**Dewey-Burdock Project
Groundwater Discharge Plan
Revision Index**

November 21, 2012 Response to August 7, 2012 Technical Comment

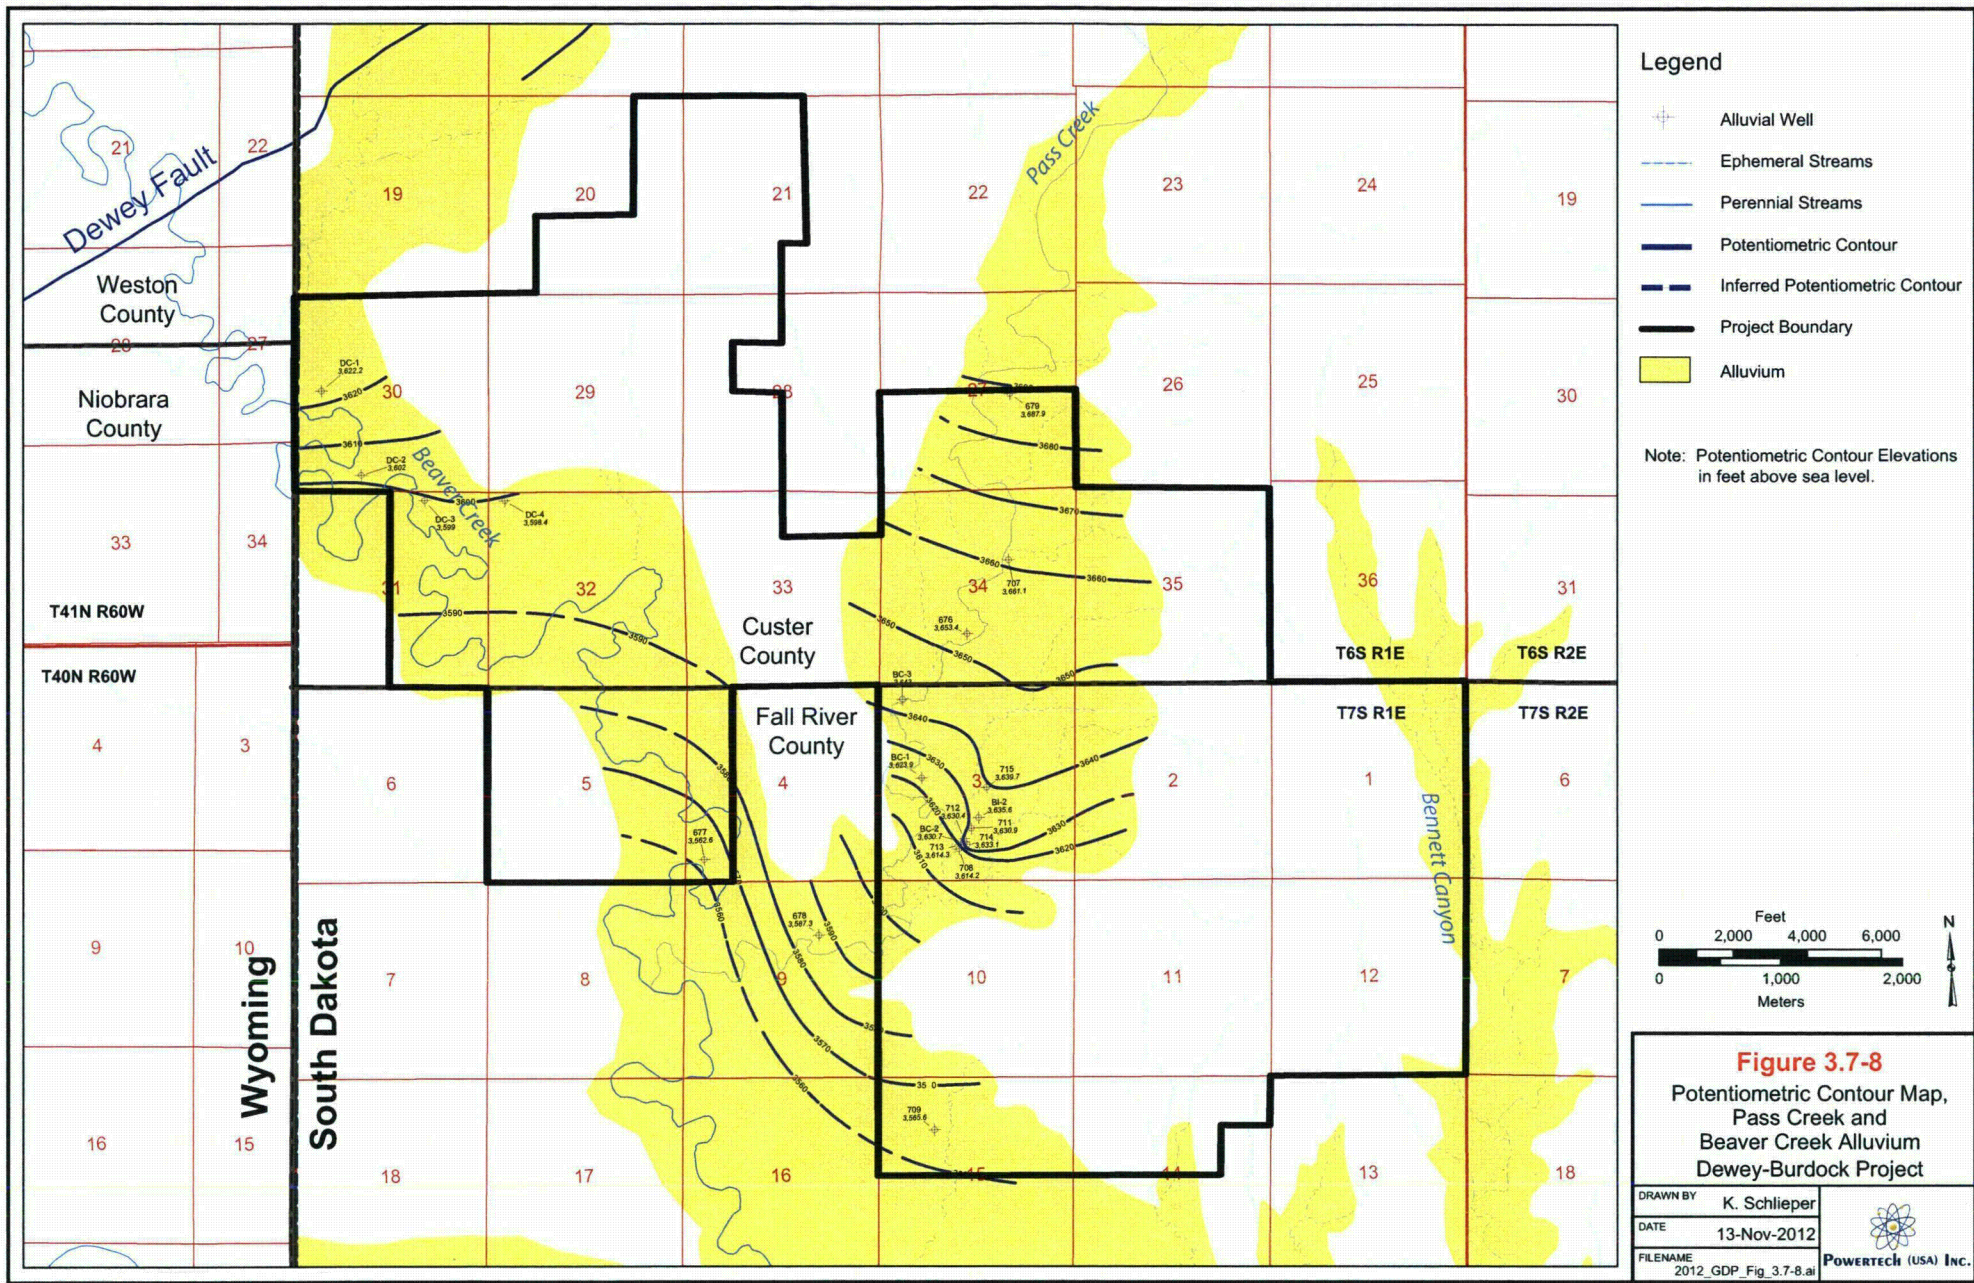
Volume	Page, Map or other Permit Entry to be Removed	Page, Map or other Permit Entry to be Added	Description of Change
1	p. 89	p. 89	Updated discussion on alluvial potentiometric contour map.
1	p. 91 (Fig. 3.7-8)	p. 91 (Fig. 3.7-8)	Updated alluvial potentiometric contour map to include November 2012 water level measurements, including those from alluvial compliance wells and additional wells near BC-2.
1	p. 152	p. 152	Corrected reference to Plate 3.6-10; updated minimum observed depth to groundwater in the Burdock land application area from 25 to 13 feet based on the November 2012 static water level measurement from well 715.
1	3.6-A-10 (App. 3.6-A)	3.6-A-10 (App. 3.6-A)	Replaced DB11-3-ALLUV-2 borehole log to remove previous note indicating water measurement was suspected of being made in error.
2	Plate 3.6-10	Plate 3.6-10	Added new Cross Section H-H' and updated Cross Sections F-F' and G-G' to reflect revised potentiometric contours based on November 2012 water level measurements.

A potentiometric surface contour map for the Pass Creek and Beaver Creek alluvium is shown on Figure 3.7-8. An isopach map for the alluvium is shown on Plate 3.6-4. The potentiometric surfaces within the alluvium show typical down-valley gradients paralleling the surface topography. The potentiometric surface in Figure 3.7-8 is based on water level measurements taken on November 5, 2012. The significant drop in the static water elevation between alluvial compliance well BC-2 and alluvial wells 708 and 713 is believed to be attributed to significant heterogeneity of the basal alluvial gravel material in this vicinity. This conclusion is supported by significant differences in water quality between wells BC-2 and 708.

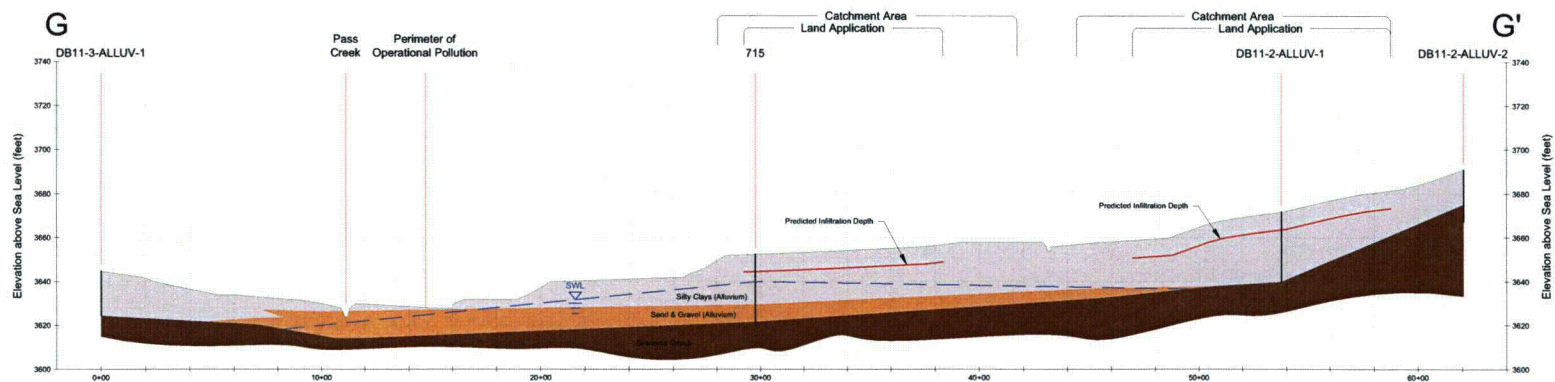
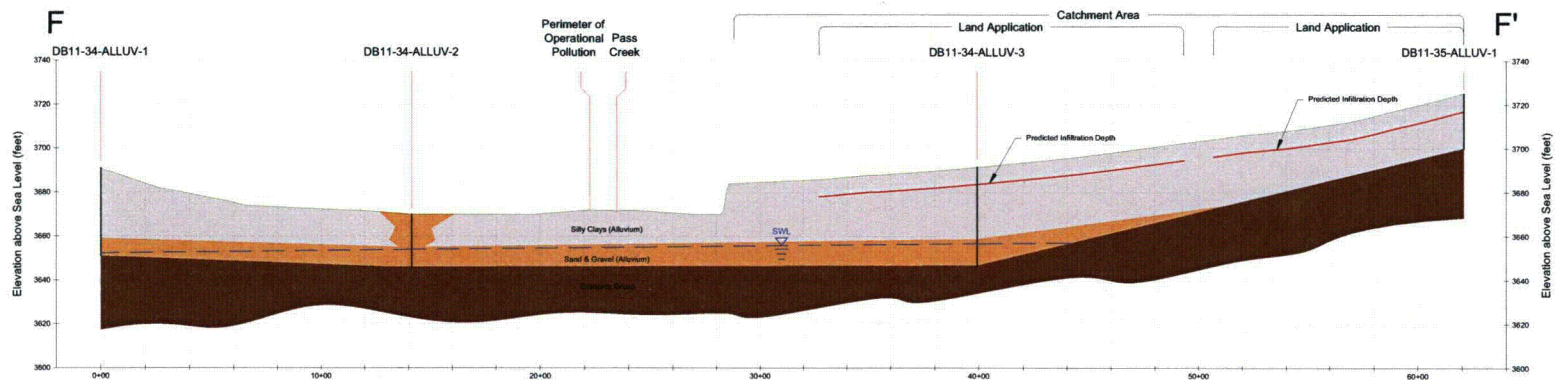
NOTE: The static water level surface depicted on the cross sections and the potentiometric contours depicted on the index map are based on Figure 3.7-8, which was prepared using November 2012 water level measurements. Potentiometric contour elevations are in feet above sea level.
